RE: JMC Project 22021
26 Chestnut Ridge Road Initial Site Plan Submission
26 Chestnut Ridge Road
Town of North Castle, New York

Response to Town's RPRC Determination

Drawn:	RB	Approved:	AN
Scale:	1" = 20'		
Date:	02/17/2022		
Project No:	22021		
Existing	EXIST	EXIST.scr	
Drawing No:	C-100

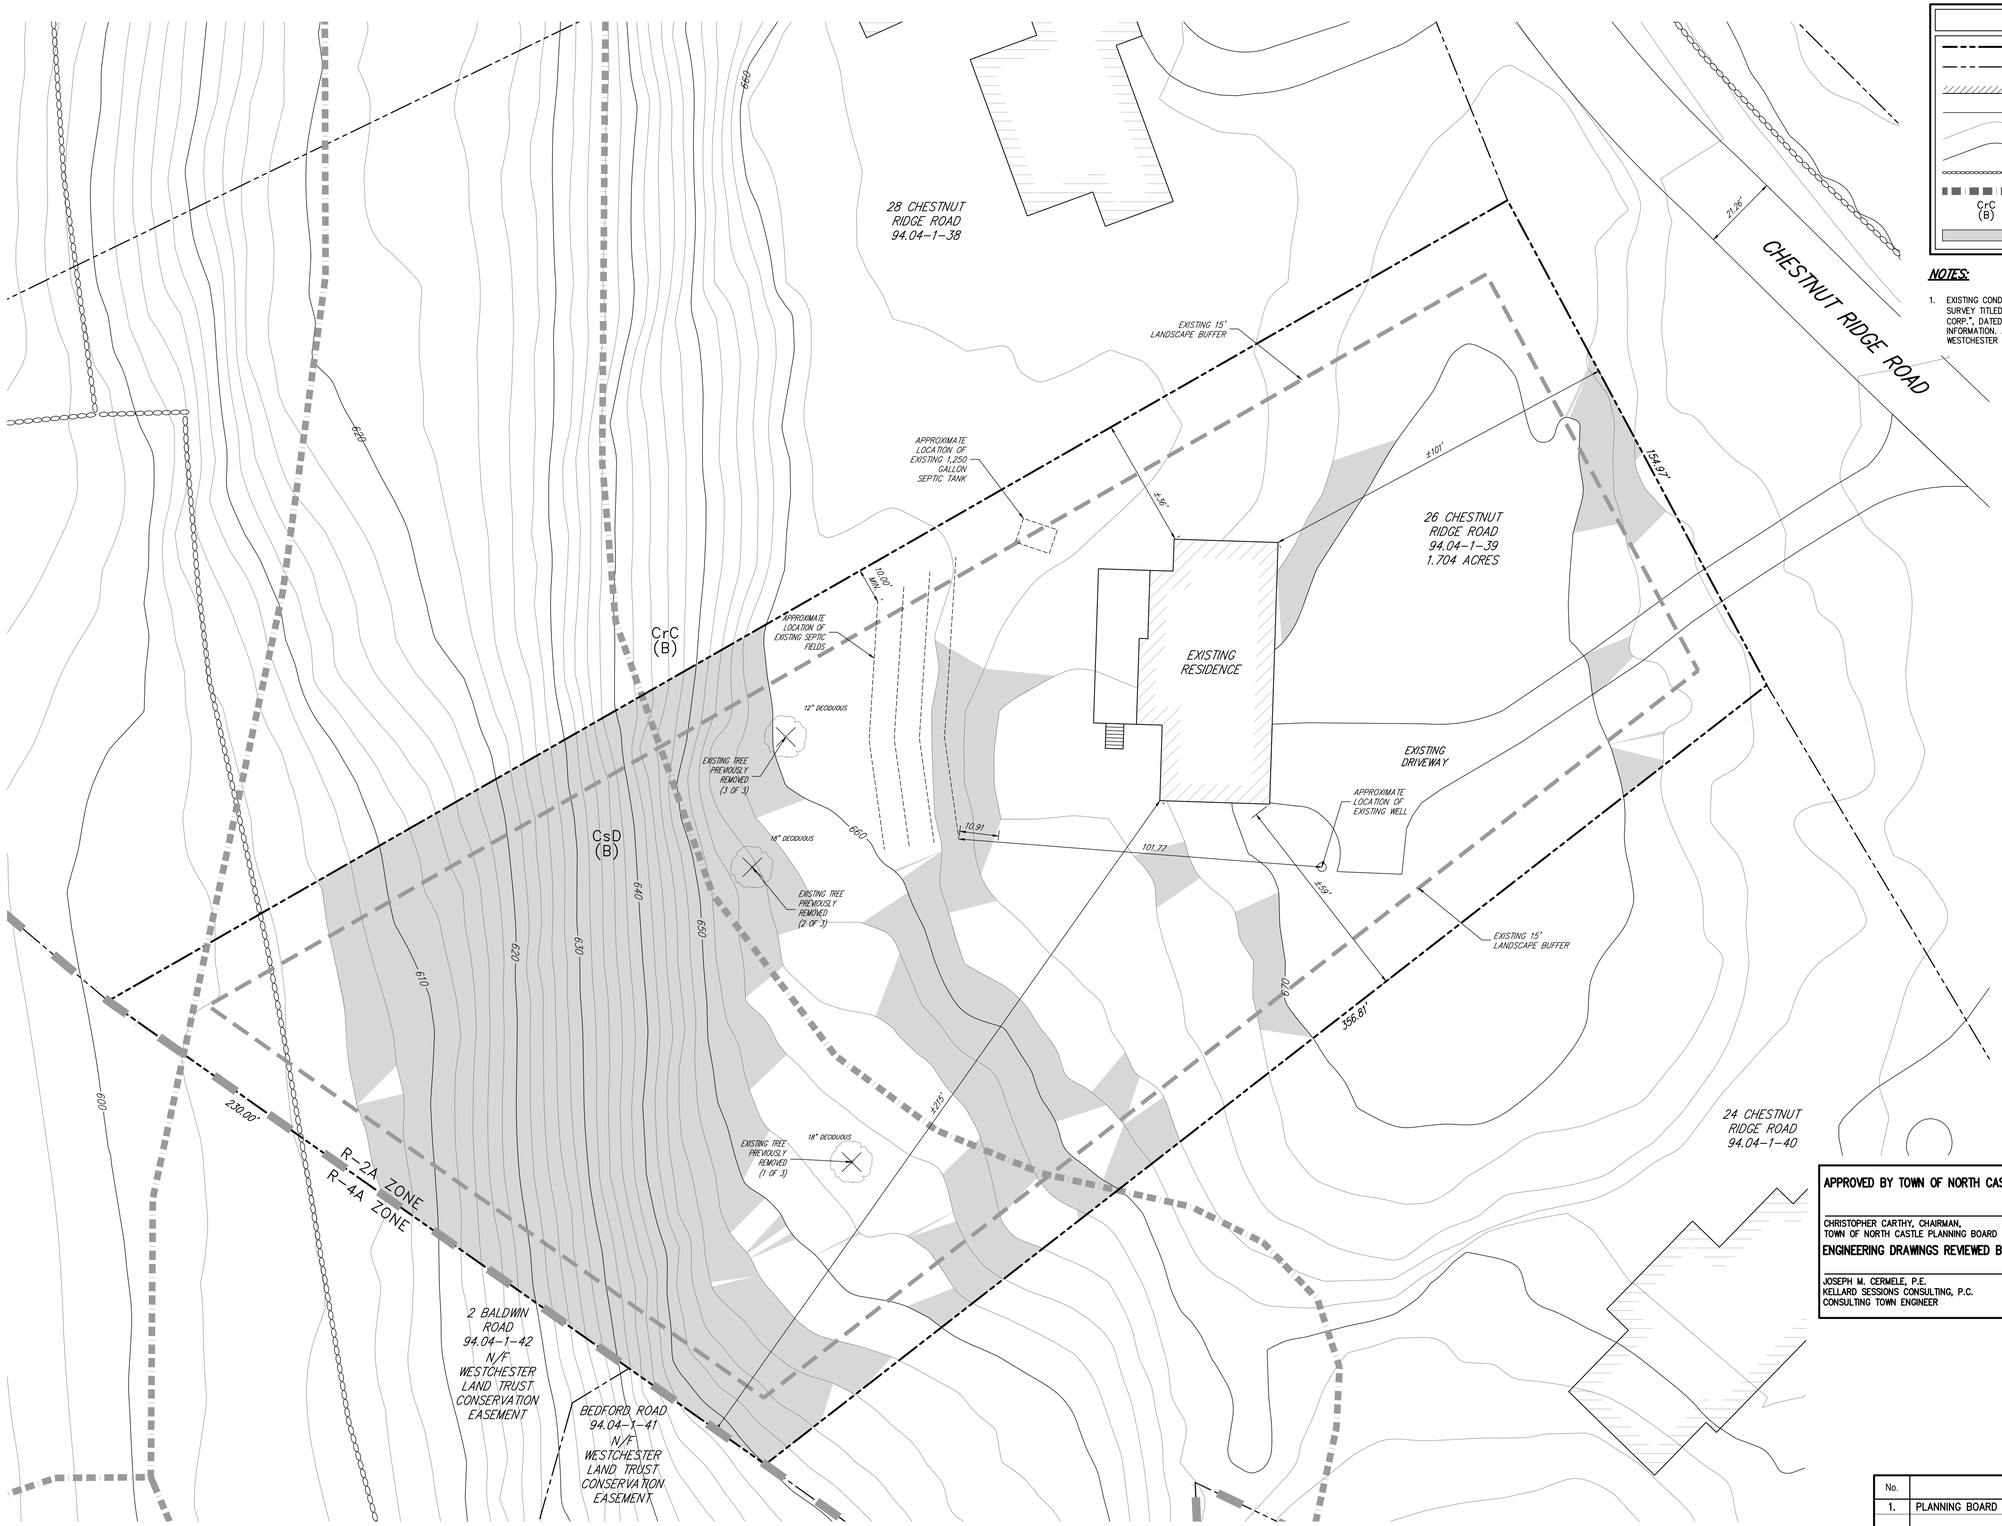
The plans shall include a note indicating the source of the survey and topographic data, including the referenced datum, utilized for the development of the plan.

Note #1 on all site plans has been updated to state that: EXISTING CONDITIONS DEPICTED ON THIS PLAN HAVE BEEN TAKEN FROM THE SURVEY TITLED "PLAN OF SEWAGE SYSTEM AS BUILT FOR T.S.I. DEVELOPMENT CORP.", DATED JUNE 3, 1981 AND SUPPLEMENTED BY WESTCHESTER GIS INFORMATION. ALL TOPOGRAPHIC INFORMATION HAS BEEN TAKEN FROM WESTCHESTER COUNTY GIS INFORMATION.

Drawing No: C-200

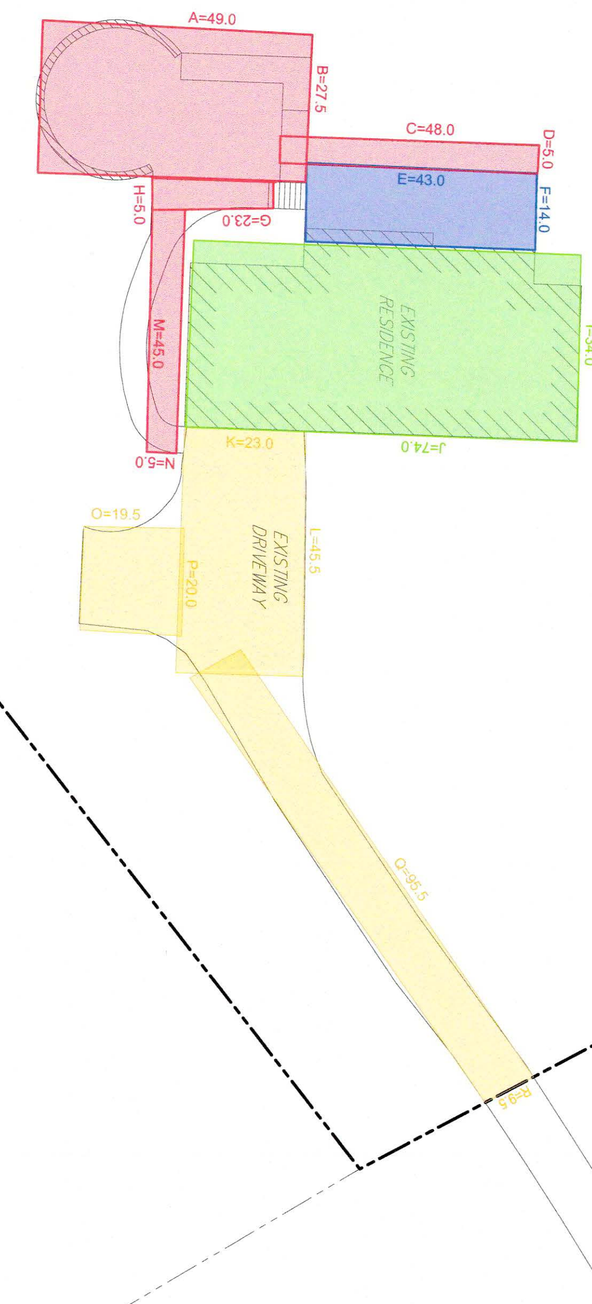
The applicant shall include a note on the plans stating: "All imported soil shall comply with Federal, State or Local regulations."

Note #15 has been added to JMC Drawing C-200. See soil manifest provided by Phoenix Environmental Laboratories, Inc., dated June 23, 2021, that has been included with this submission package.
